**RE: Water Licence 2AM-MRY1325 May 2019 Inspection Report**

Attachment 1: 2AM-MRY1325 May 2019 Inspection Report

WATER LICENCE INSPECTION FORM

Date	Camera	Inspector	Authorization
August 22, 2018	Sony Cyber-shot	J.Mesher	2AM-MRY1325
<b>Photo Log</b>		<b>Location Baffinland</b>	
Photo 1

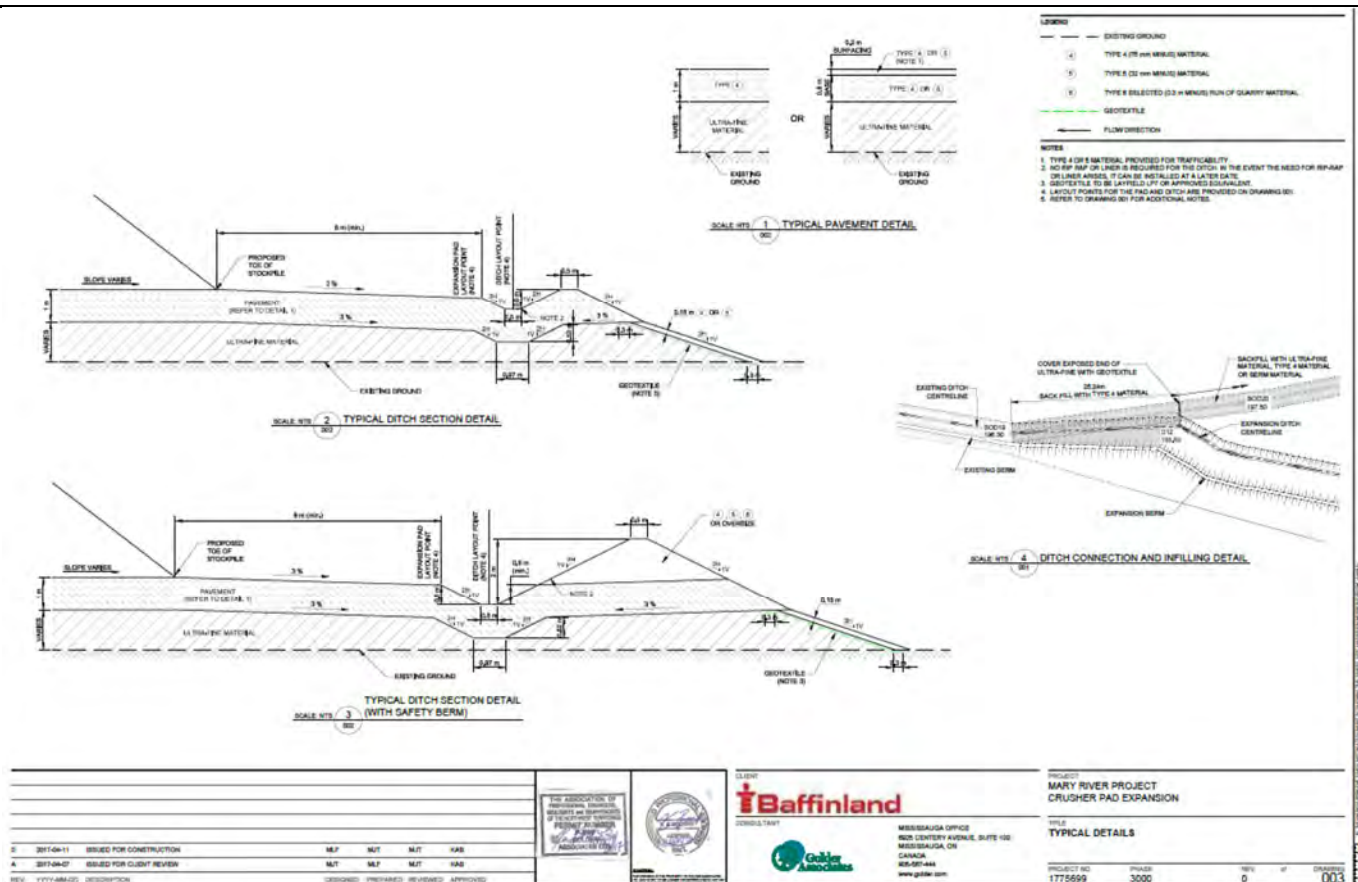
- c. As mentioned in previous inspection reports the slope of the ditches surrounding this facility do not appear to be consistent with the approved design and the construction material does not appear to be the approve size. (see Photo 1).

**Description:** Pooling in unlined ditches of the Crusher pad

1c	As mentioned in previous inspection reports the slope of the ditches surrounding this facility do not appear to be consistent with the approved design and the construction material does not appear to be the approve size. (see Photo 1).
